November 30, 2020

**Re: SIR Addendum - Response to RIDEM SIR Comments  
Former Hope Mill (5 Main Street, Scituate, RI)  
RIDEM No. SR-30-0623A (Formerly Case No. 2007-010 and Part of SR-30-0623)  
ESS Project No. P312-009**

**ALL SOIL SAMPLES IN WETLAND RESTORATION AREA**

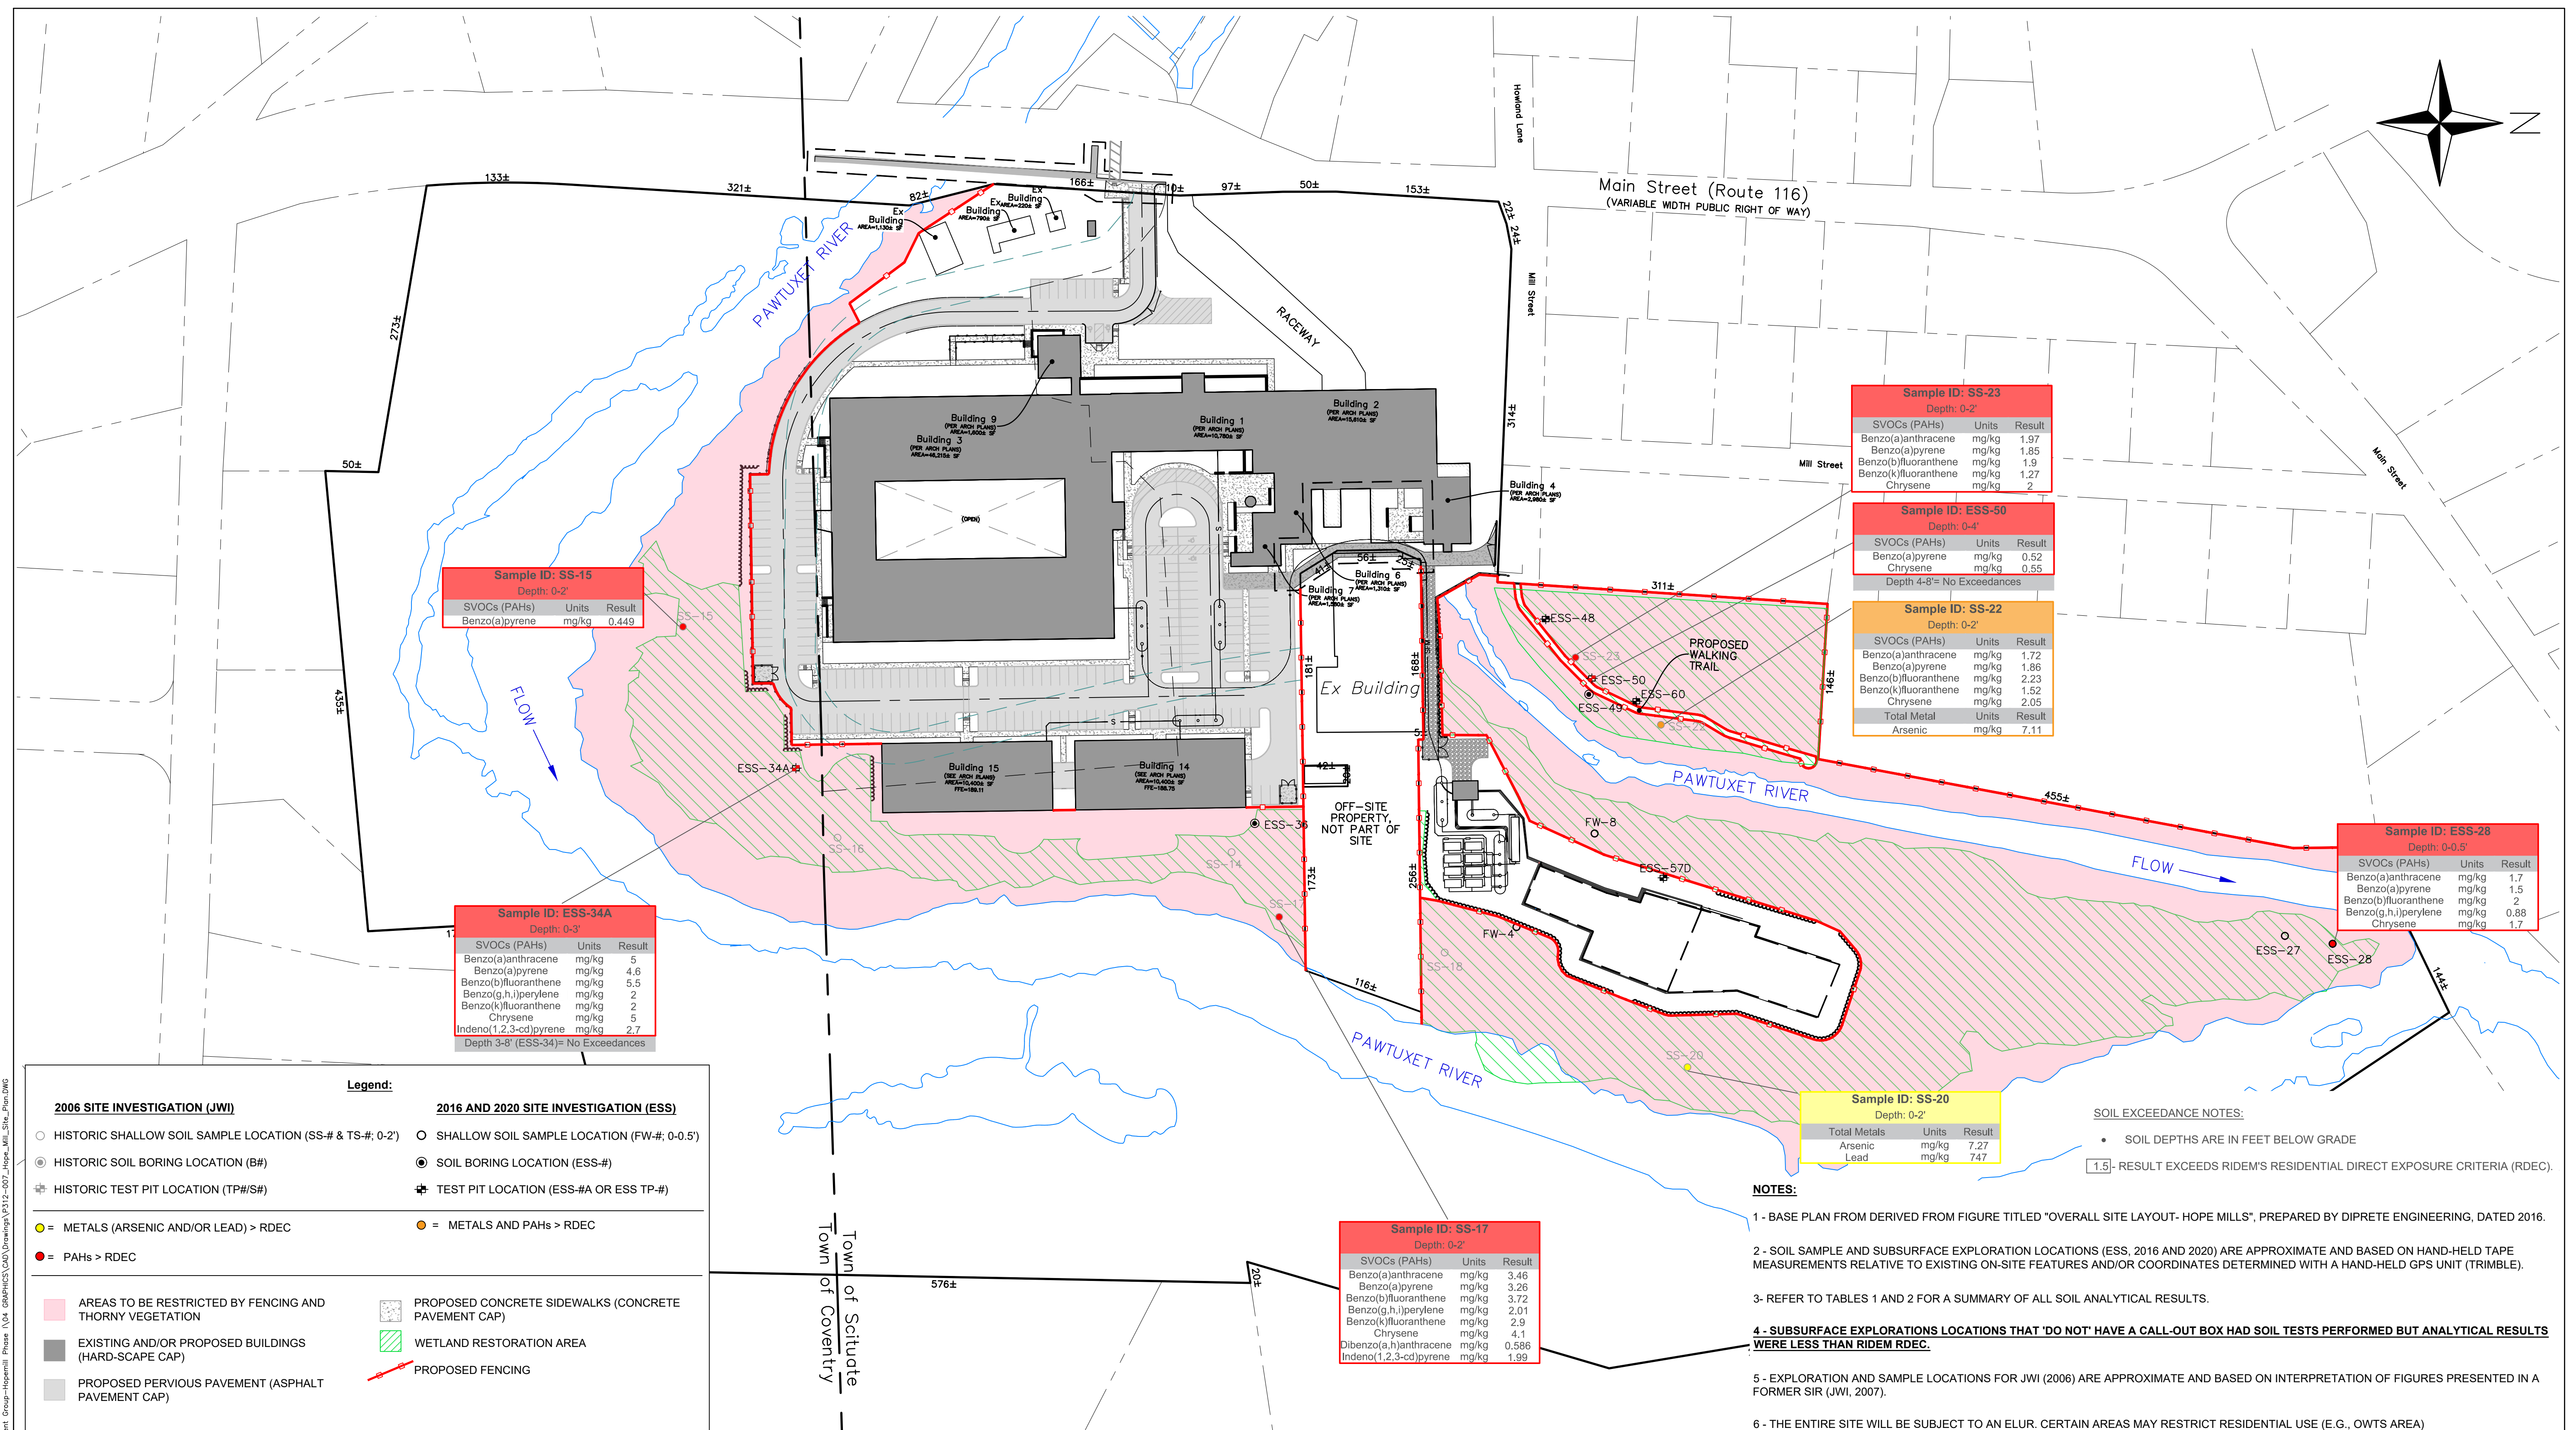
- c. Please submit a figure in the SIR Addendum, similar to the emailed draft Proposed Remedy Plan, but which also clearly shows all identified COC exceedances in areas that will be subject to wetlands restoration and are not being proposed for targeted excavation or capping activities. The Department acknowledges that many or all of these areas are proposed for installation of fencing and thorny brush to restrict or prevent future access and will be further subject to the restrictions of the ELUR.

*ESS Response: Two updated figures (Figure 8 – Soil Exceedances in Wetland Restoration Area; and Figure 8A – All Soil Samples in Wetland Restoration Area) are attached.*
